PLANNING REVIEW

180 EL CAMINO REAL, BLDG D, SUITE #136B
STORE NO. TBD,
LEVEL: GROUND LEVEL
PALO ALTO, CA 94304

SUBMITTAL
PLANNING REVIEW 2/26/24

DELAROSA
180 EL CAMINO REAL,
BLDG D,
SUITE #136B
PALO ALTO, CA 94304

EXISTING/DEMO
FLOOR PLAN

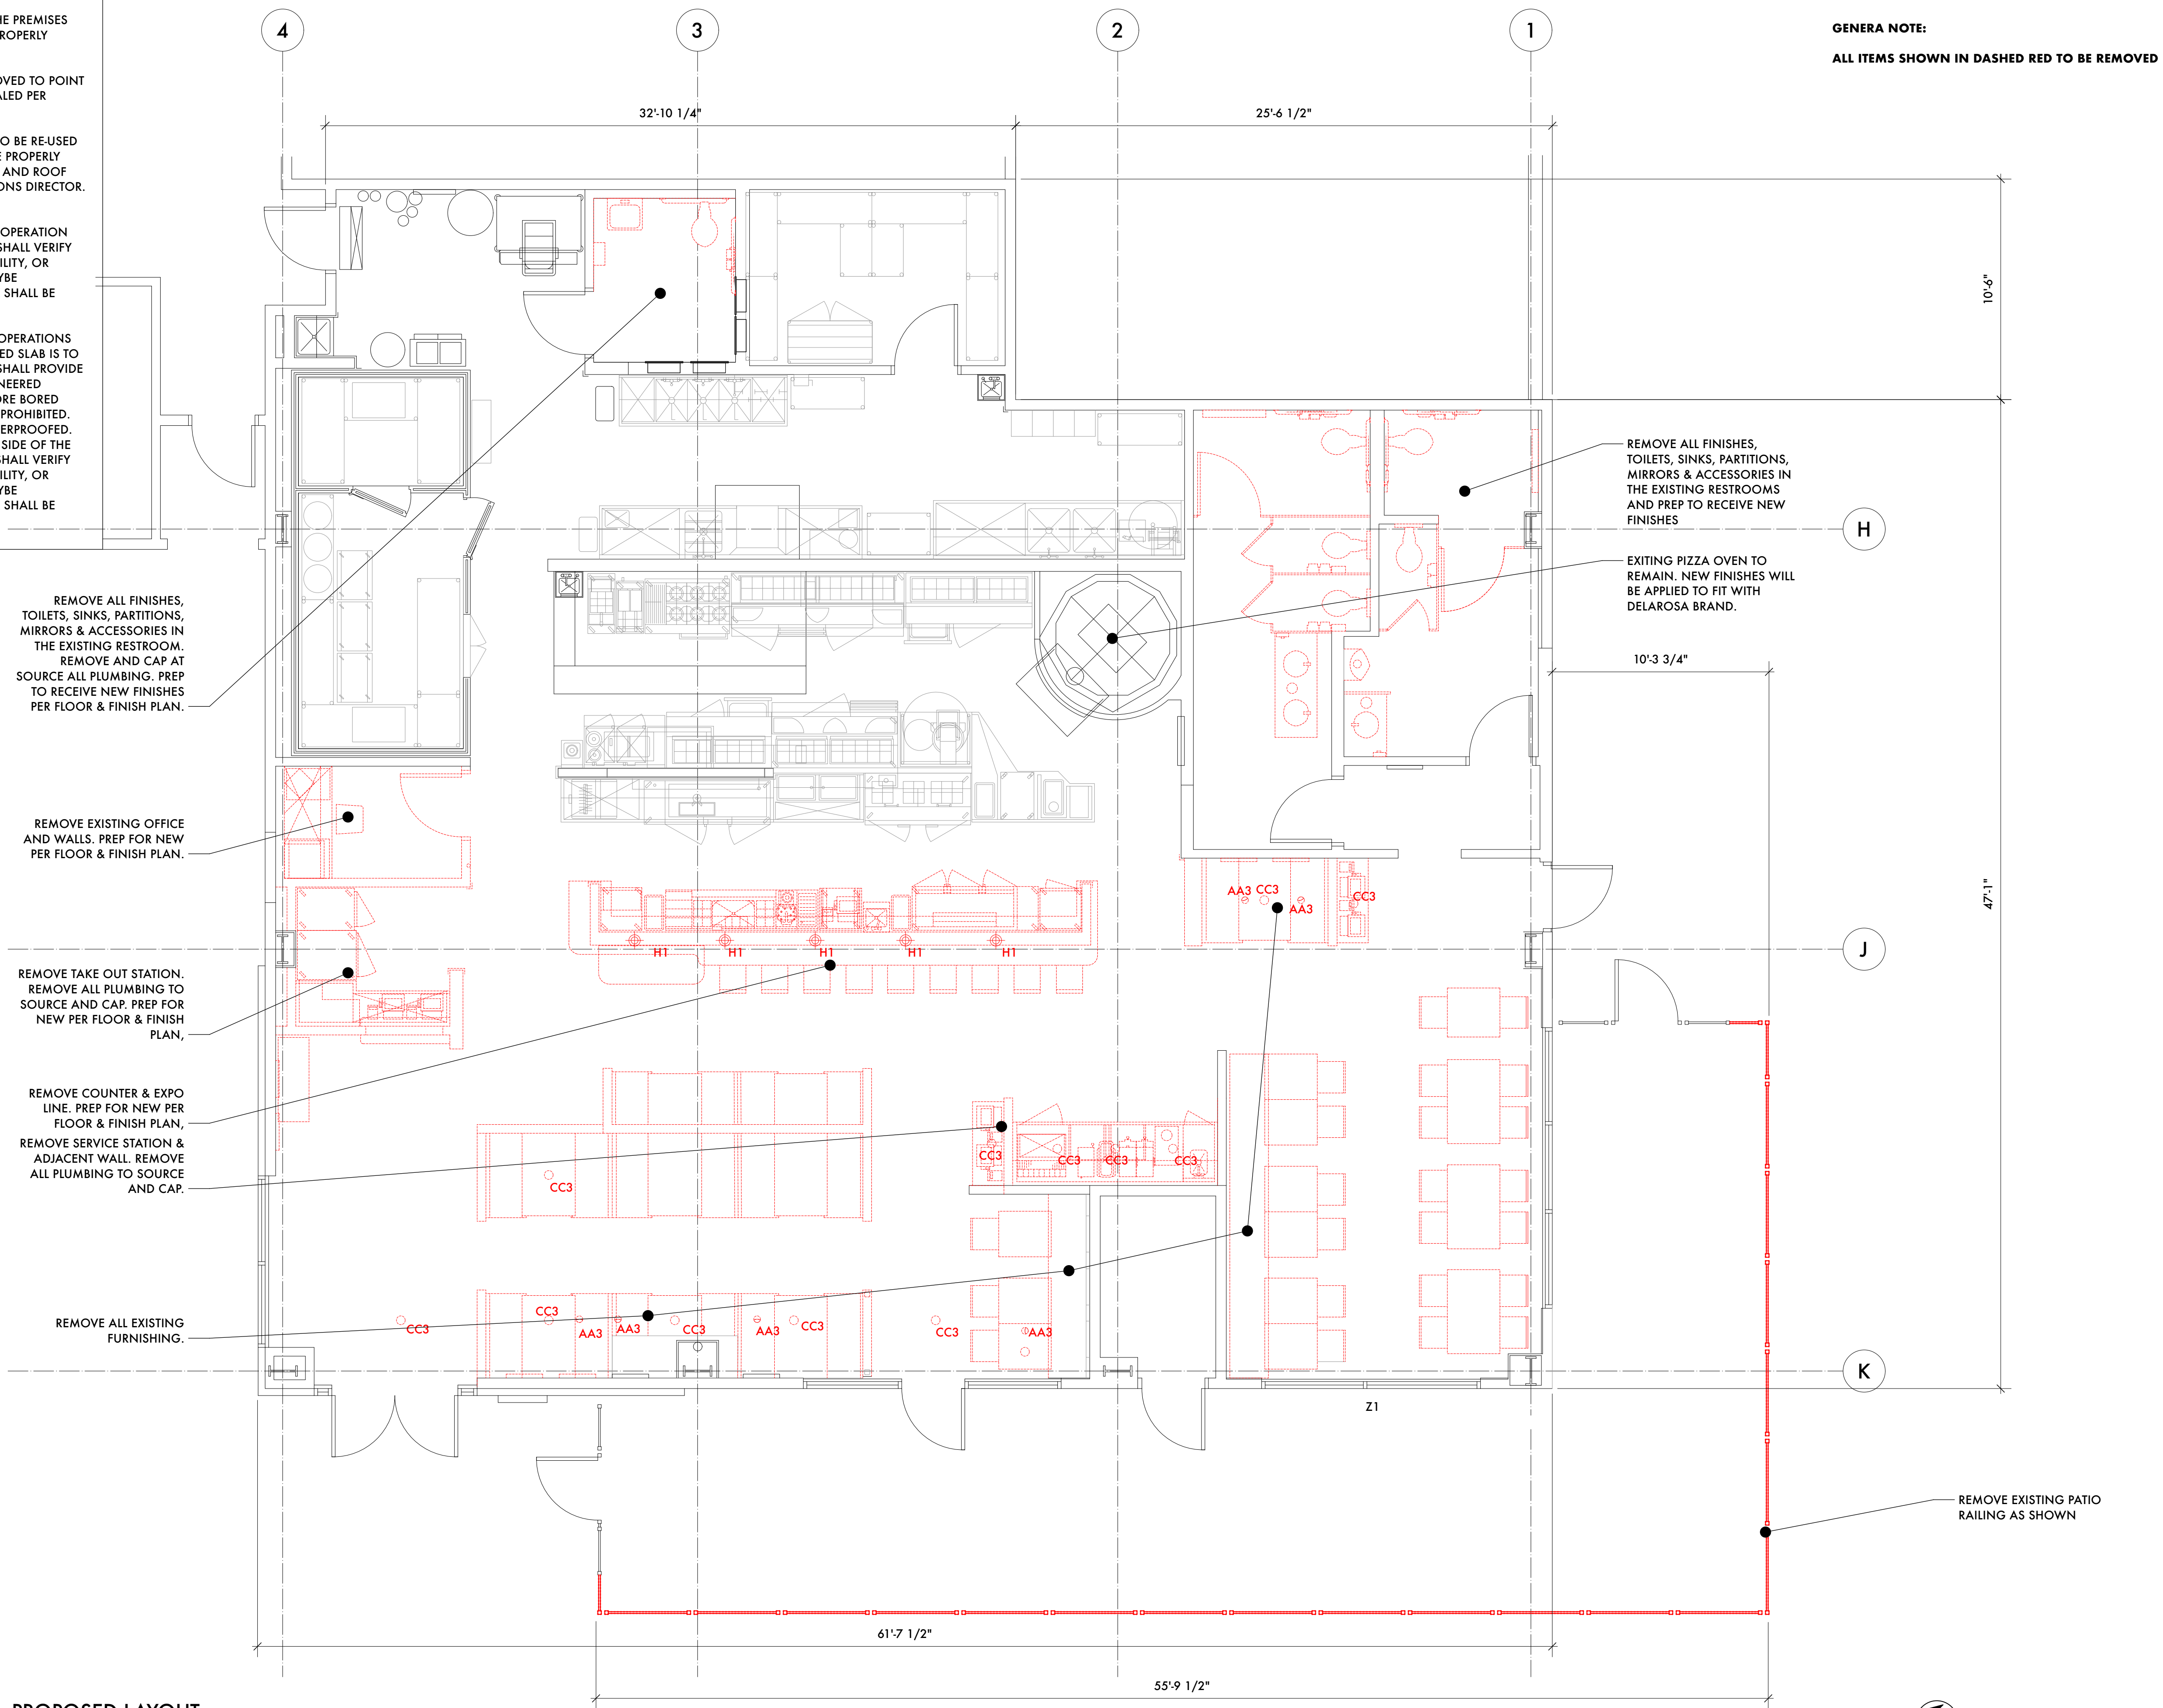
• CONTRACTORS SHALL FIELD VERIFY ALL FIELD CONDITIONS PRIOR TO THE START OF ANY CONSTRUCTION. BE ADVISED THAT ALL CHANGES AND MODIFICATION TO THE LANDLORD'S APPROVED DRAWINGS SHALL BE RESUBMITTED TO LANDLORD FOR RE-APPROVAL. ANY CONSTRUCTION COMPLETED WITH OUT LANDLORD APPROVAL SHALL BE CORRECTED AS APPROVED BY LANDLORD AT TENANT'S EXPENSE.

• ALL ABOVE GROUND UTILITY LINES NOT TO BE RE-USED MUST BE REMOVED TO POINT OF ORIGIN. ALL UNDER SLAB UTILITY LINES TO BE CUT, CAPPED AND SEALED PER CODE.

• **SLAB REQUIREMENTS:**
SLAB ON GRADE: TENANT'S GENERAL CONTRACTOR SHALL ADVISE THE OPERATION TEAM PRIOR TO ANY SLAB MODIFICATIONS OR REMOVAL. TENANT GC SHALL VERIFY THAT WORK SHALL NOT CONFLICT WITH ANY EXISTING STRUCTURAL, UTILITY, OR OTHER UNDER-SLAB CONDITION. (NONDESTRUCTIVE VERIFICATION MAYBE REQUIRED.) ANY DAMAGE OR DOWNTIME CAUSED BY TENANT'S WORK SHALL BE REPAIRED AND REIMBURSED AT TENANT'S EXPENSE.

ELEVATED SLABS: TENANT'S GENERAL CONTRACTOR SHALL ADVISE THE OPERATIONS TEAM PRIOR TO ANY SLAB MODIFICATION OR REMOVAL. IF ANY ELEVATED SLAB IS TO BE MODIFIED IN ANYWAY (DRILLED, CORED, OR PENETRATED), TENANT SHALL PROVIDE STAMPED AND CERTIFIED DRAWINGS BY A LICENSED STRUCTURAL ENGINEER CERTIFIED IN THE LOCAL JURISDICTION. ALL PENETRATIONS SHALL BE CORE BORED ONLY. SAW CUTTING, JACK HAMMERING, AND TRENCHING IS STRICTLY PROHIBITED. ALL PENETRATIONS SHALL BE SLEEVED, SEALED, FIRE STOPPED, AND WATERPROOFED. ALL PENETRATIONS SHALL BE IDENTIFIED BY A TAG ON EITHER SIDE OF THE SLAB, AND BE LABELED WITH THE REQUIRED NAPA RATING. TENANT GC SHALL VERIFY THAT WORK SHALL NOT CONFLICT WITH ANY EXISTING STRUCTURAL, UTILITY, OR OTHER UNDER-SLAB CONDITION. (NONDESTRUCTIVE VERIFICATION MAYBE REQUIRED.) ANY DAMAGE OR DOWNTIME CAUSED BY TENANT'S WORK SHALL BE REPAIRED AND REIMBURSED AT TENANT'S EXPENSE.

PROPOSED LAYOUT
Scale: 1/4" = 1'-0"

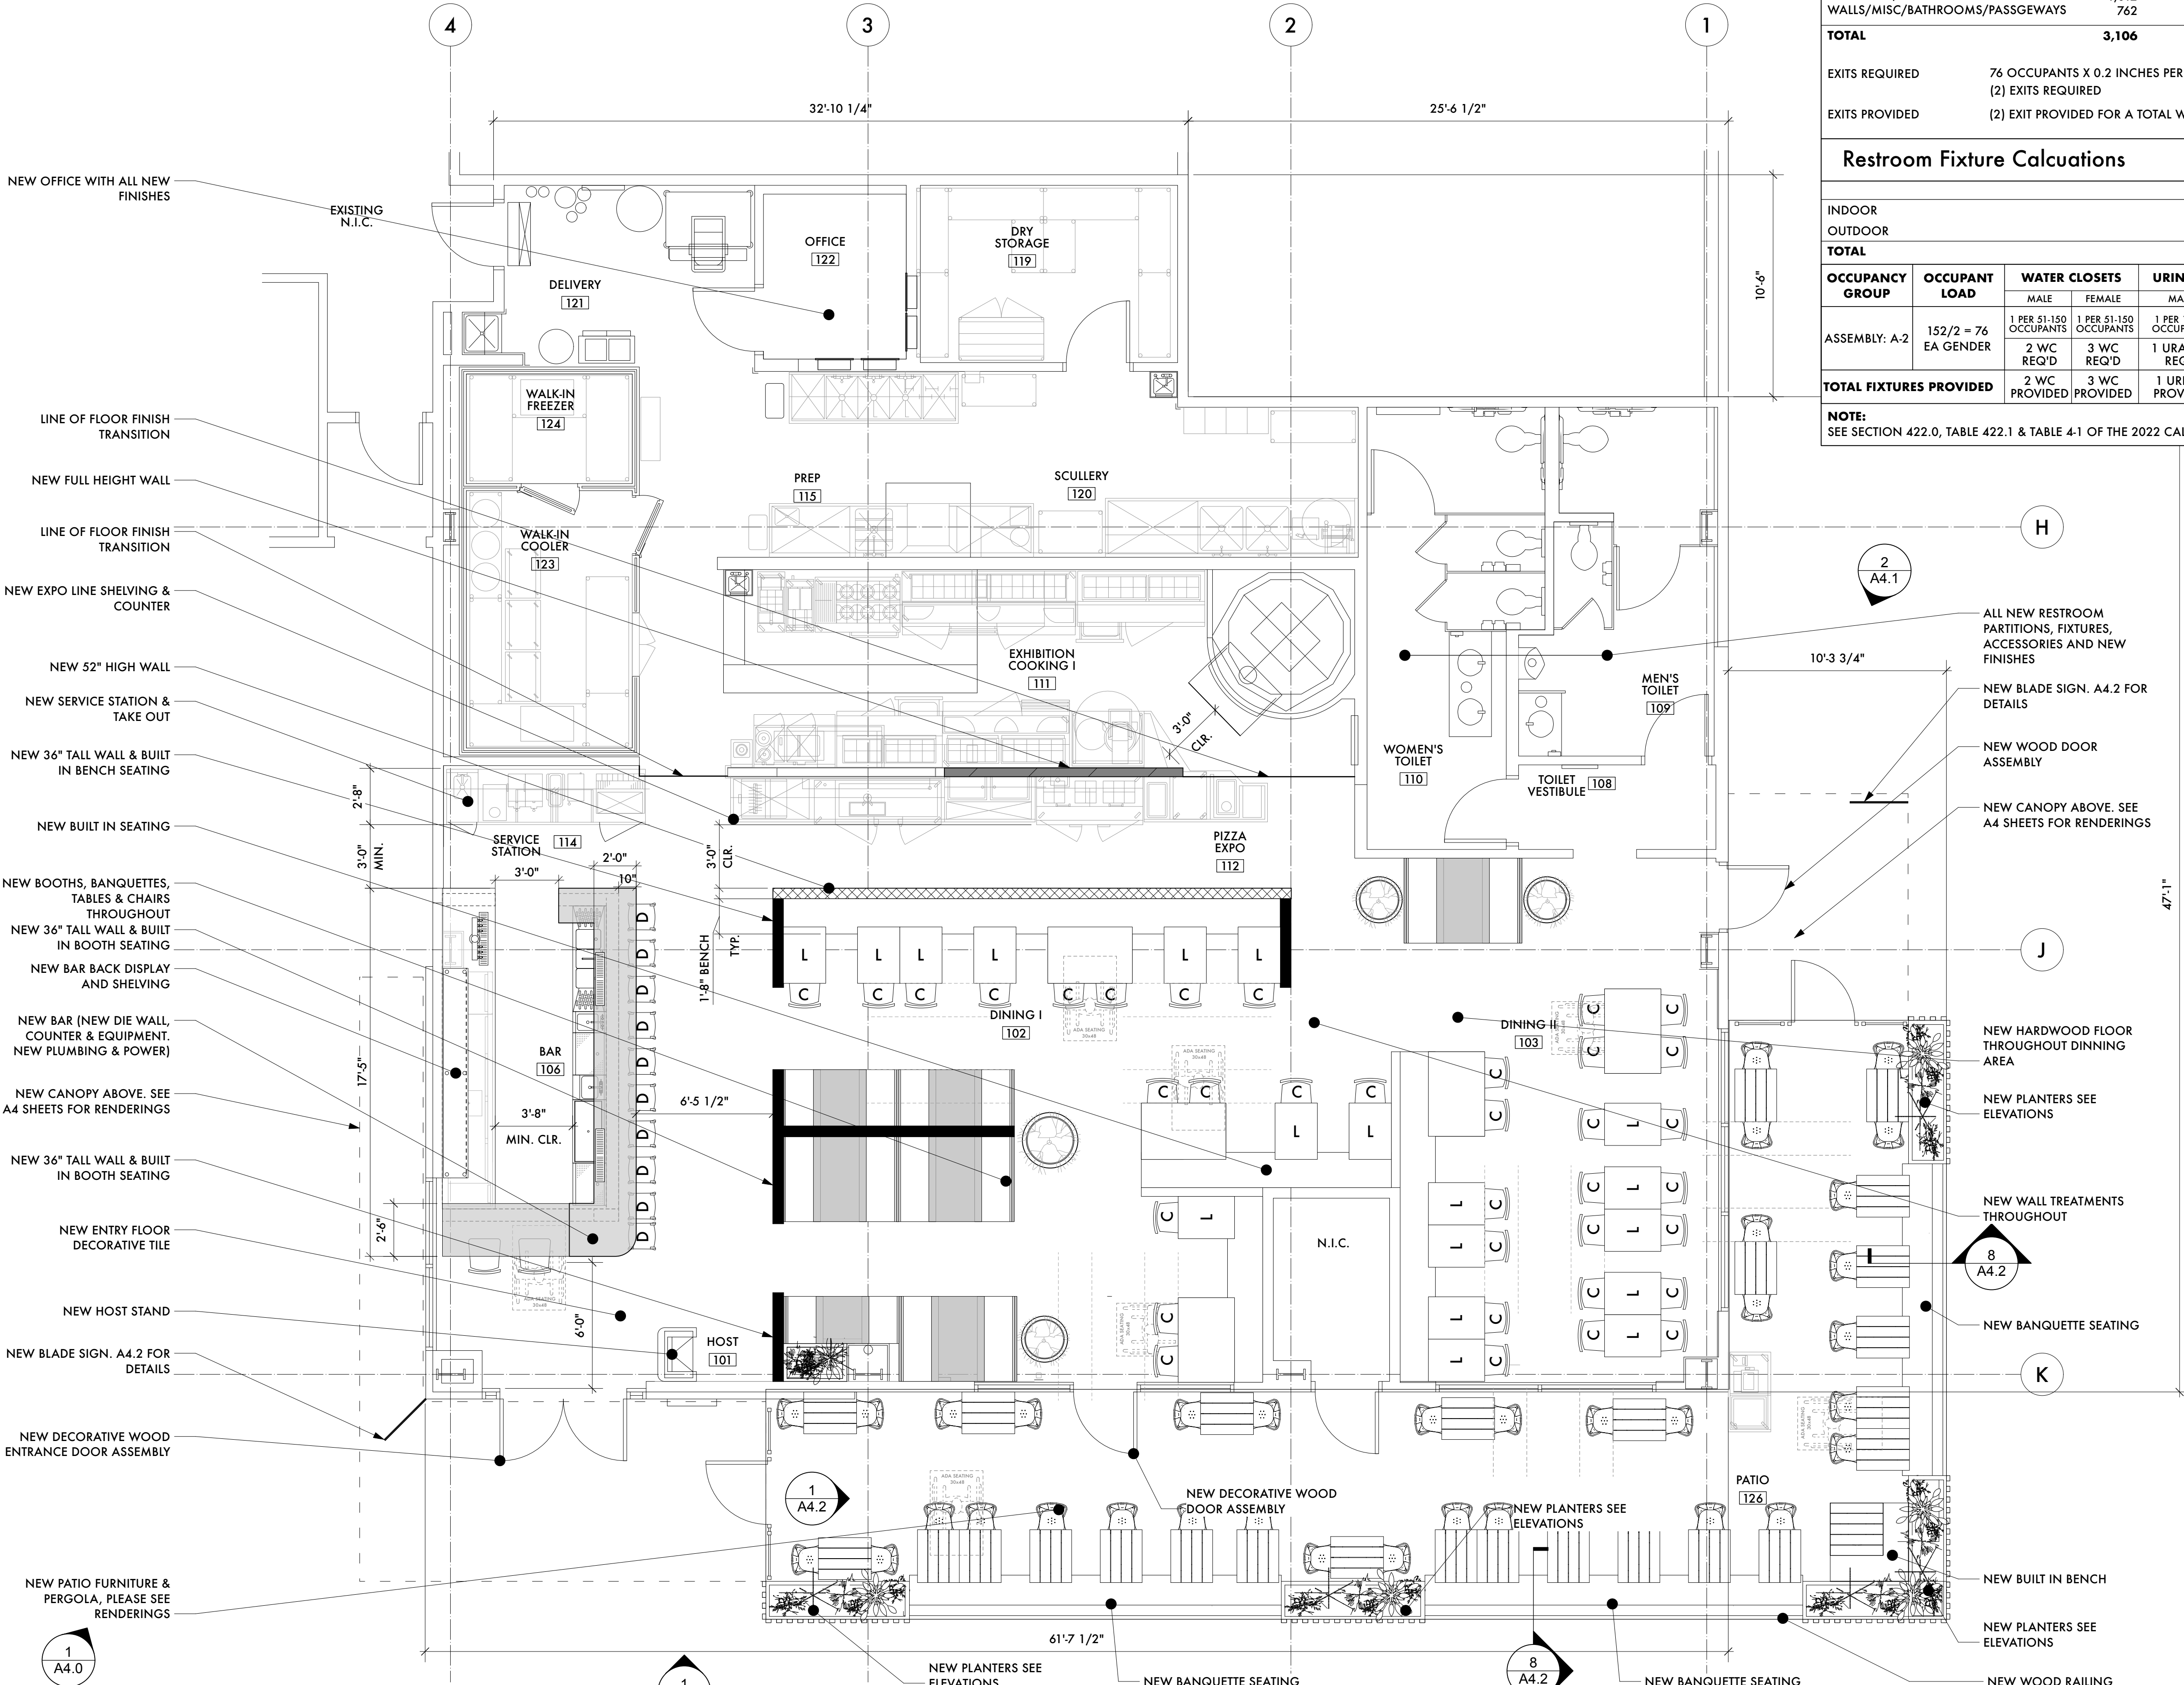
LL PLAN COMMENTS:
• ALL FLOORING TRANSITIONS MUST BE SMOOTH AND FLUSH. THE USE OF PLASTIC, VINYL, OR RUBBER TRANSITIONS STRIPS IS STRICTLY PROHIBITED. TENANTS MUST UTILIZE A HARD SURFACE TRANSITION.

• TENANT IS REQUIRED TO INSTALL A WATERPROOF MEMBRANE IN ALL WET AREAS (RESTROOMS, KITCHENS, FOOD SERVICES, ETC...) OF THE SPACE. TENANT SHALL USE A 30 MIL POLYETHYLENE CLEAVAGE MEMBRANE (EQUAL TO NOBLESEAL TS) INSTALLED PER MANUFACTURERS RECOMMENDATIONS AND ANSI A108. MEMBRANE MUST BE EXTENDED UP THE WALL A MINIMUM OF 6" OR EQUAL TO THE HEIGHT OF THE FLOOR BASE.

• NO RUBBER OR VINYL BASE IS PERMITTED IN THE SALES AREA OF THE PREMISES.

• GC TO FIELD VERIFY ALL EXISTING CONDITIONS AND DIMENSIONS IN THE SPACE. FAILURE TO PROPERLY FIELD VERIFY EXISTING CONDITIONS DOES NOT RELIEVE THE TENANT OF ANY EXPENSES OR RESPONSIBILITIES RESULTING FROM THAT FAILURE.

• NOTHING IS PERMITTED TO BE ATTACHED TO, SUSPENDED FROM, OR PENETRATE LANDLORD'S STRUCTURE, FLOOR DECK, OR ROOF DECK. YOU MAY ATTACH, NON-DESTRUCTIVELY, TO OR SUSPEND FROM THE TOP CHORD OF THE JOIST OR THE STRUCTURAL STEEL WHICH EXISTS ABOVE THE TENANT SPACE. WHEN ATTACHING TO LANDLORD'S STRUCTURE, **DO NOT DRILL, WELD, SCREW, OR SHOOT** INTO STRUCTURE. ALTERNATIVE METHODS OF ATTACHMENT ONLY, NOTHING TO DAMAGE LANDLORD'S BASE BUILDING STRUCTURE. TENANT SHALL PROVIDE SIGNED AND SEALED STRUCTURAL DRAWINGS, BY A STRUCTURAL ENGINEER WITH LEGALLY ACTIVE REGISTRATION AS INDICATED BY ALL JURISDICTIONAL REQUIREMENTS, FOR ALL STRUCTURAL MODIFICATIONS FOR LANDLORD RECORDS.

• ANY LANDLORD EQUIPMENT, COMPONENT, AND / OR SERVICE FEEDING OTHER TENANT(S) THAT IS EXISTING IN THE SPACE MUST REMAIN VISIBLE AND ACCESSIBLE TO THE LANDLORD. TENANT SHALL INSTALL ACCESS PANELS AS REQUIRED TO MAINTAIN ACCESS. ACCESS PANELS SHALL BE LABEL TO PROPERLY IDENTIFY SYSTEM, COORDINATE WITH MALL OPERATIONS.

• ALL REAR ENTRIES MUST HAVE A DOORBELL FOR DELIVERIES.

• ALL CONCRETE PATCHING MUST BE LEVEL WITH THE EXISTING CONCRETE FLOOR.

• TENANT IS REQUIRED TO INSTALL A WATERPROOF MEMBRANE IN ALL WET AREAS (RESTROOMS, KITCHENS, FOOD SERVICES, ETC...) OF THE SPACE. TENANT SHALL USE A 30 MIL POLYETHYLENE CLEAVAGE MEMBRANE (EQUAL TO NOBLESEAL TS) INSTALLED PER MANUFACTURERS RECOMMENDATIONS AND ANSI A108. MEMBRANE MUST BE EXTENDED UP THE WALL A MINIMUM OF 4" OR EQUAL TO THE HEIGHT OF THE FLOOR BASE.

DISPLAY FIXTURES, RACKS, SHELVING, AND STORAGE UNIT REQUIREMENTS:

• TENANT SHALL BE SOLELY RESPONSIBLE FOR THE DESIGN, INSTALLATION, AND USE OF ANY DISPLAY OR STORAGE SYSTEM(S) WITHIN THE PREMISE INCLUDING ALL COMPLIANCE WITH APPLICABLE BUILDING CODES, FIRE CODES AND THE REQUIREMENTS OF ANY INSURANCE RATING BUREAUS. IF ANYTHING DONE, OMITTED TO BE DONE OR SUFFERED TO BE DONE BY TENANT IN, UPON OR ABOUT THE PREMISES IN REGARD TO SUCH DISPLAY OR STORAGE SYSTEM(S) SHALL RESULT IN A FIRE CODE VIOLATION(S) AND THE TENANT FAILS TO TAKE CORRECTIVE ACTION AND / OR PAY THE ASSOCIATED FINE, REGARDLESS OF WHETHER ASSESSED AGAINST TENANT OR LANDLORD, WITHIN THE PRESCRIBED TIME PERIOD, THEN TENANT SHALL BE LIABLE FOR ALL COSTS AND EXPENSES RESULTING FROM SUCH VIOLATION(S) AND LANDLORD SHALL HAVE THE RIGHT TO CORRECT ANY SUCH CONDITION(S) AT TENANT'S EXPENSE.

• TENANT DISPLAY FIXTURES IN THE RETAIL SPACE AND RACK / SHELVING / STORAGE UNITS IN THE STOCKROOM SHALL BE DESIGNED TO PROVIDE ADEQUATE CLEARANCE FOR THE AUTOMATIC (FIRE) SPRINKLER SYSTEM. NO DISPLAYS OR STORAGE SHOULD EXCEED 12FT AND CEILINGS MUST BE INSTALLED TO PROVIDE A MINIMUM OF 18" OF CLEARANCE BETWEEN THE TOP OF THE STORAGE SYSTEM AND SPRINKLER DEFLECTORS.

• TENANT DISPLAYS OR STORAGE HIGHER THAN 12'-0" ARE CLASSIFIED AS "HIGH PILED STORAGE", WHICH REQUIRES HIGH HAZARDOUS AUTOMATIC (FIRE) SPRINKLER PROTECTION DESIGNED PER FM GLOBAL LOSS PREVENTION DATA SHEET AND NFPA REQUIREMENTS FOR THE STORAGE OF "GROUP A PLASTIC" COMMODITIES. HIGH PILED STORAGE ALSO REQUIRES A MINIMUM OF 36" OF CLEARANCE BETWEEN THE TOP OF STORAGE AND SPRINKLER DEFLECTORS.

• TENANT MOBILE / COMPACT STORAGE SYSTEMS SHALL BE CONSTRUCTED OF WIRE MESH SHELVES. HOWEVER, IF CONSTRUCTED WITH SOLID SHELVES (WOOD OR STEEL), THE UNITS SHALL BE INSTALLED WITH A MINIMUM OF A 3" SPACER TO PROVIDE SPACE BETWEEN UNITS AT MAXIMUM 5'-0" INTERVALS.

• TENANT'S ARCHITECT AND GENERAL CONTRACTOR SHALL PROVIDE THE FOLLOWING INFORMATION TO THE MALL REQUIRED SPRINKLER CONTRACTOR REGARDING STOCK / STORAGE AREA:
* TYPE OF STORAGE SYSTEM(S). (INCLUDING DETAILS OF THE STORAGE SYSTEM(S)).
* TYPE OF SHELVING. (WIRE MESH / SOLID WOOD / SOLID STEEL, ETC.) O TYPE OF COMMODITIES. (PLASTICS, AEROSOLS, CLOTHING, ETC)
* ELEVATION OF HIGHEST SHELF / CEILING HEIGHT.
